Addendum No. 4

Project: Taxiway Rehabilitation and Electrical Improvements

Airport: Texas Gulf Coast Regional Airport

KSA Project No.: 103006

1 L-880B(L) PAPI INSTALLATION DETAIL
 EL507 SCALE: N.T.S.

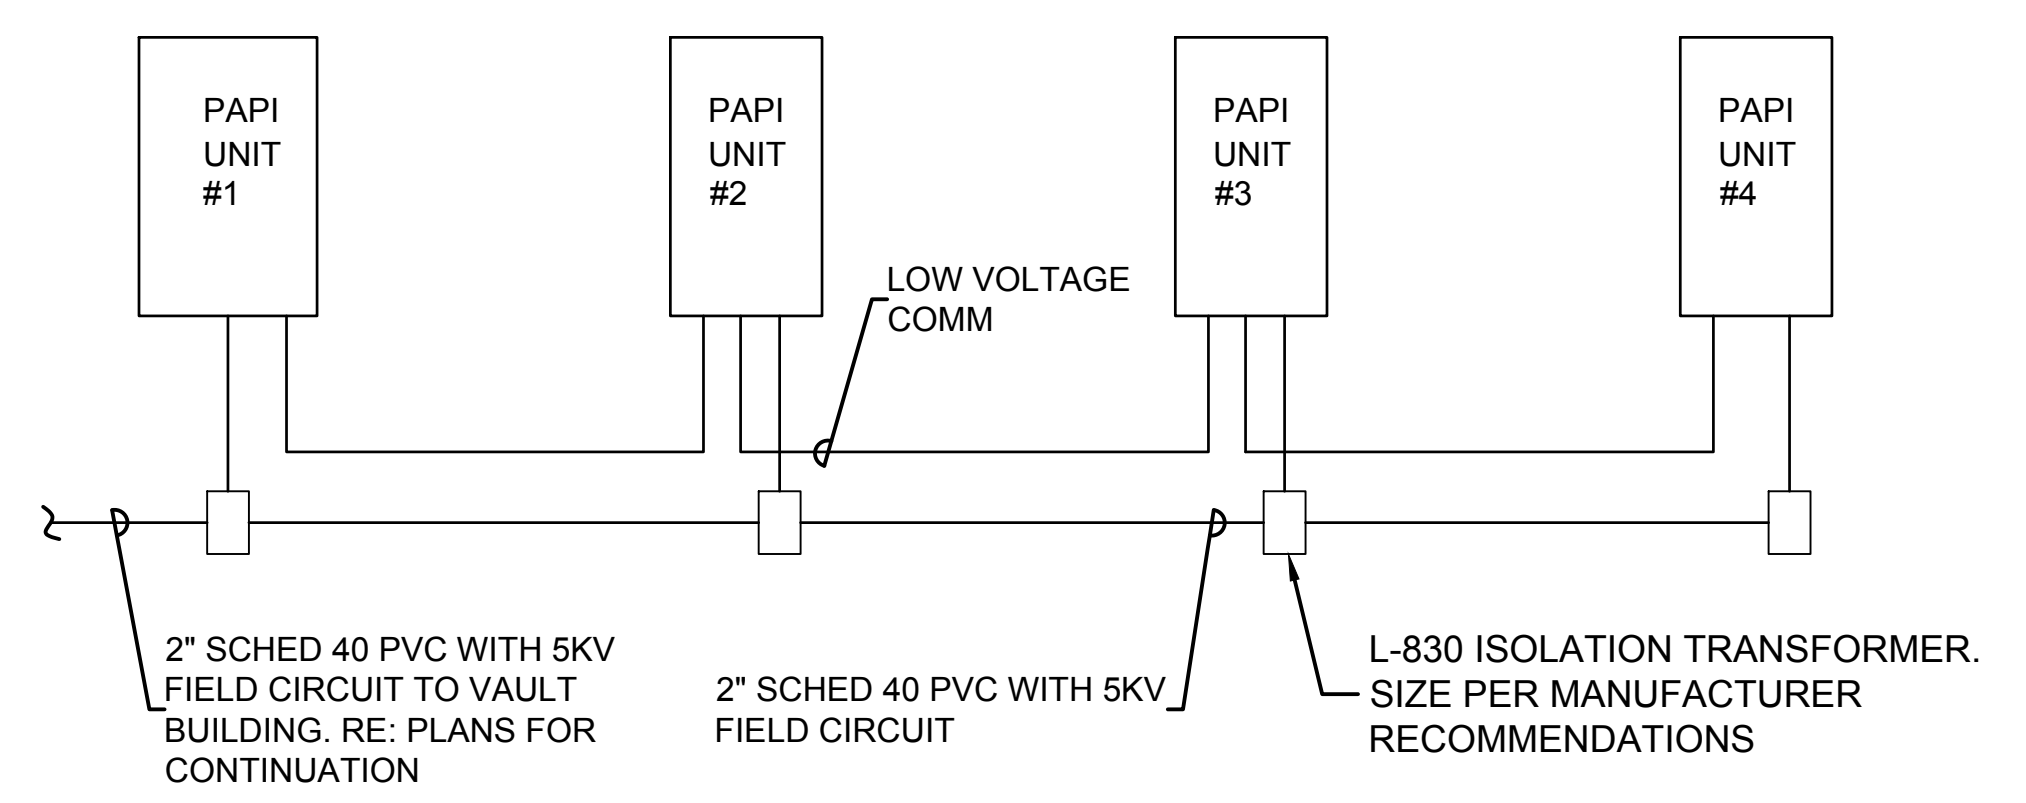
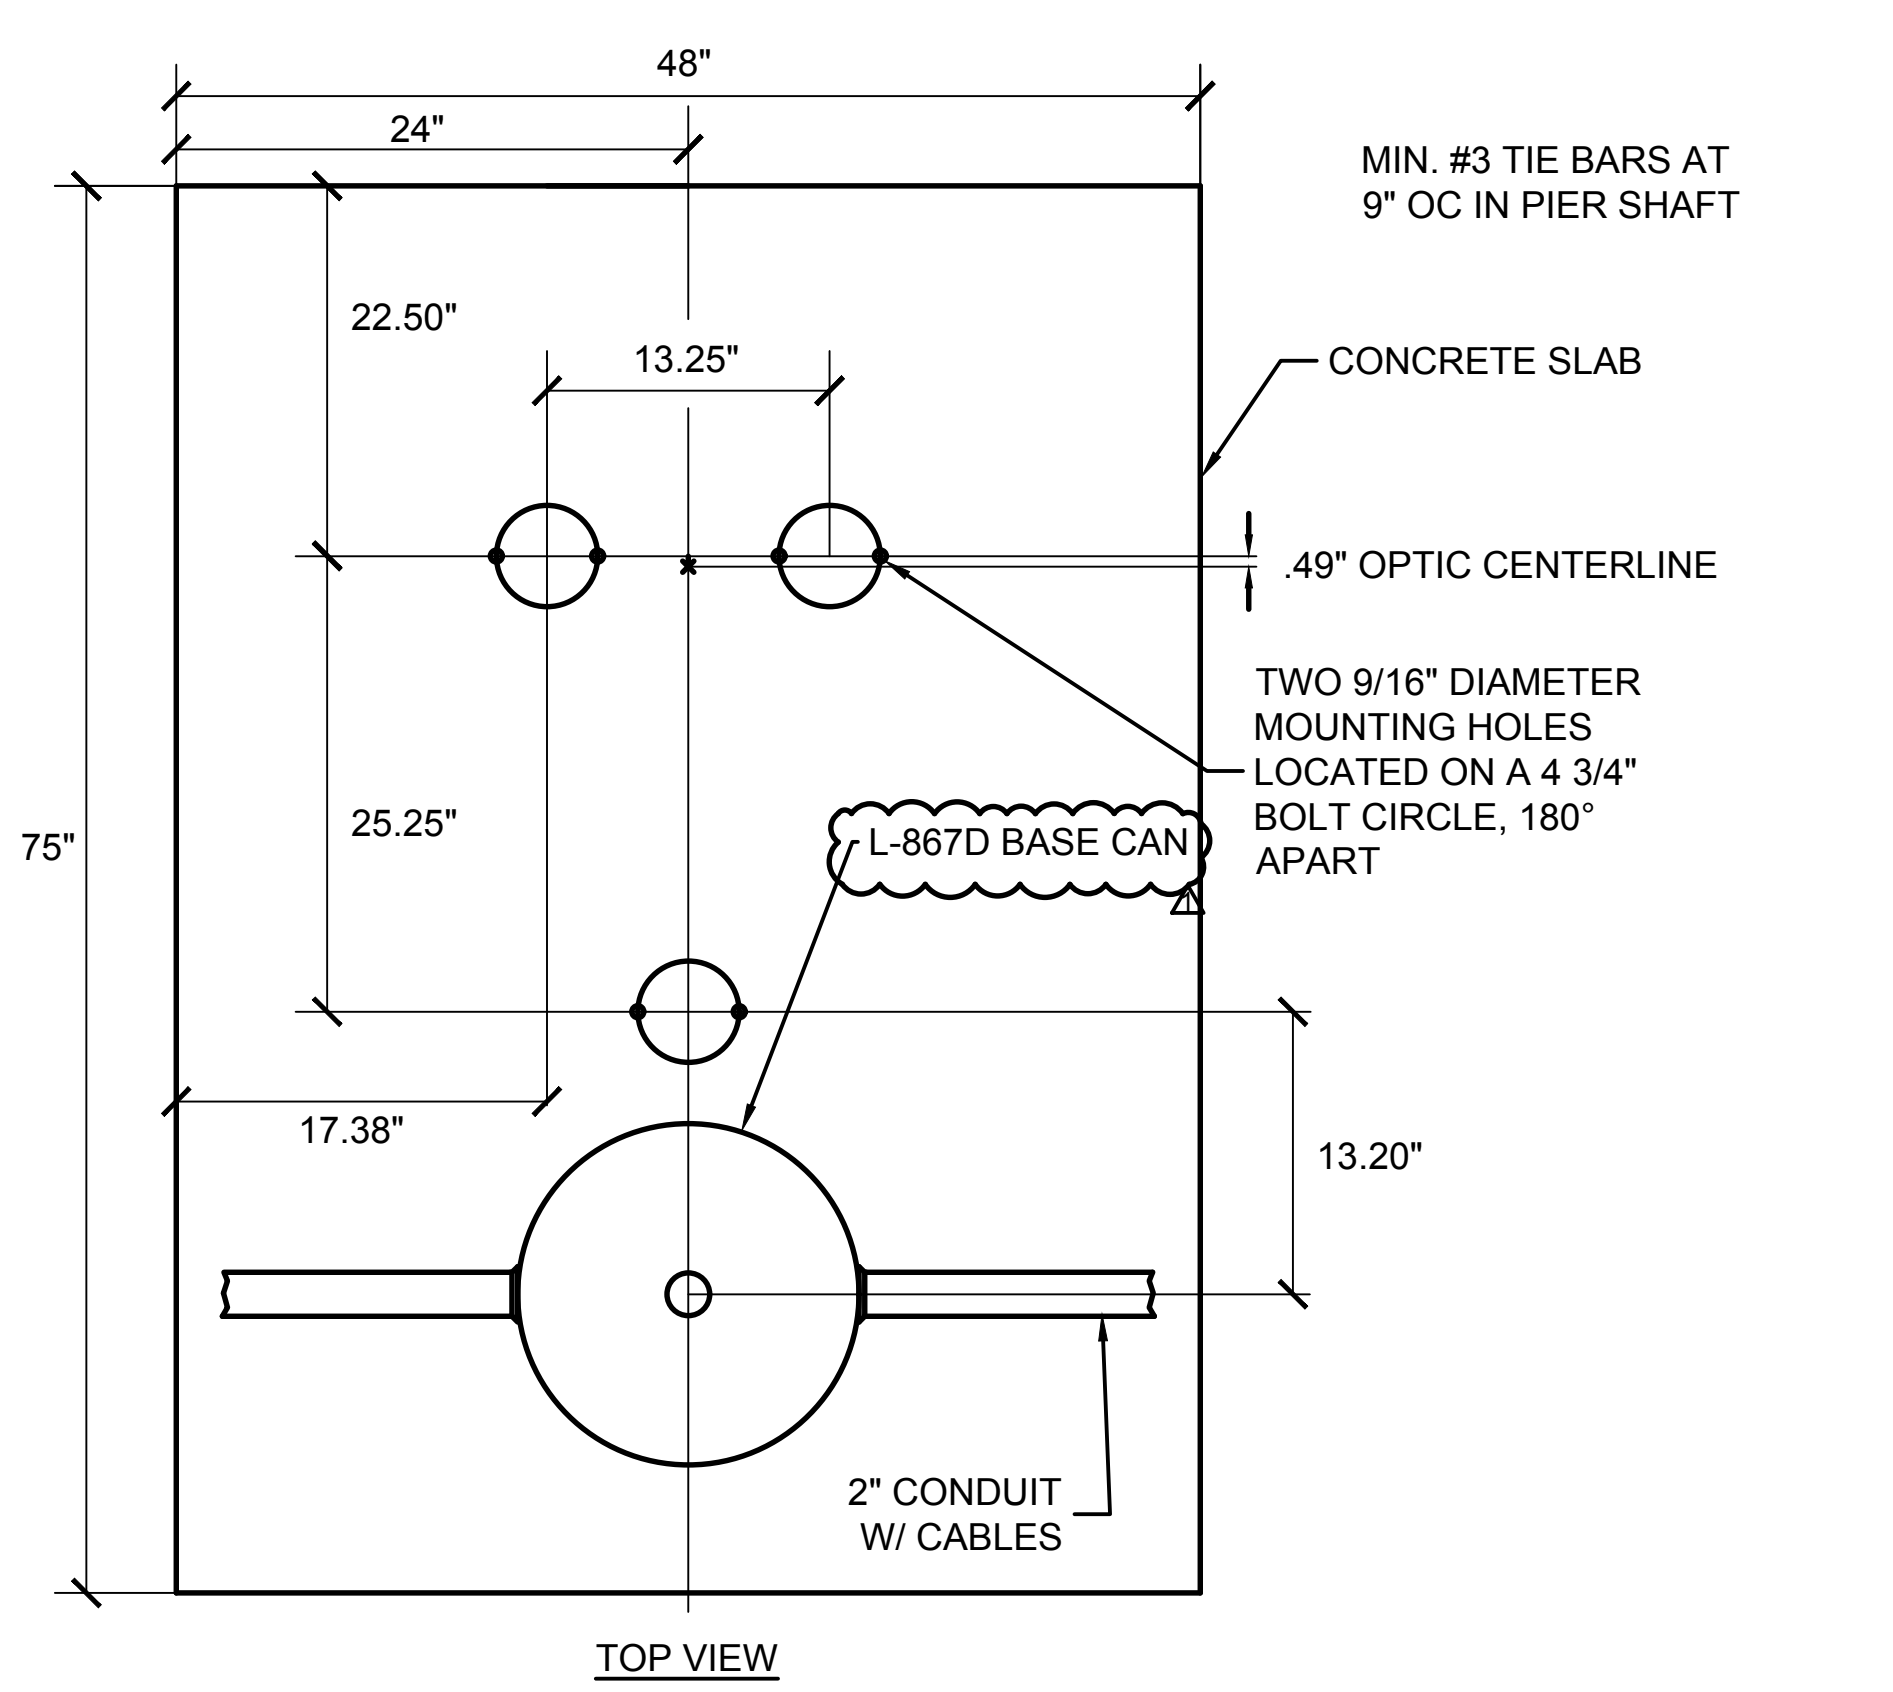
4. Question: Installation detail for the Style A PAPI sheet EL508 is showing both L867B and L867D components. Which is proper base, Size B or D, that shall be provided? Will the bases require additional hubs between bases as shown for the Style B PAPI on sheet EL507?
